HIGHWAY WORK PROPOSAL

<u>COUNTY</u>	<u>STATE PROJECT</u>	<u>FEDERAL</u>	<u>PROJECT DESCRIPTION</u>	<u>HIGHWAY</u>
Calumet	4580-11-60	N/A	Sherwood-Hilbert; Sth 55-Sth 32	STH 114

ADDENDUM REQUIRED ATTACHED AT BACK

Addendum No. 01
ID 4580-11-60
Added Sheet 11A
May 1, 2019

LONGITUDINAL DETAIL FOR CULVERT PIPE FROST HEAVE REPAIR AREA

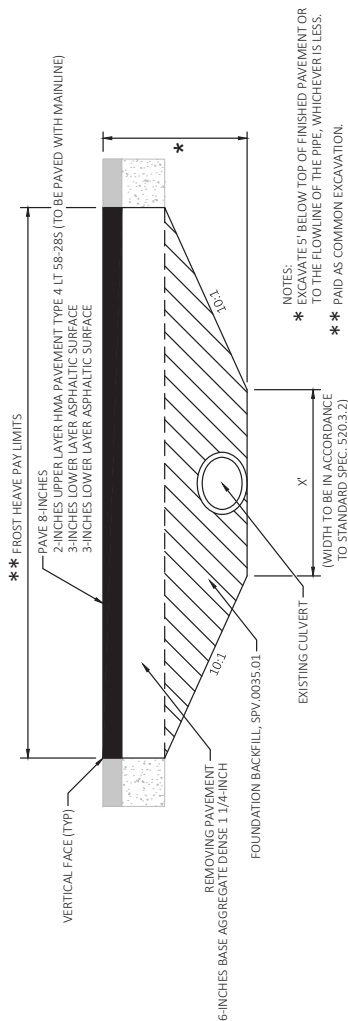
STATIONS: 116+72, 124+07, 138+90, 145+74, 192+97, 222+10, 250+27
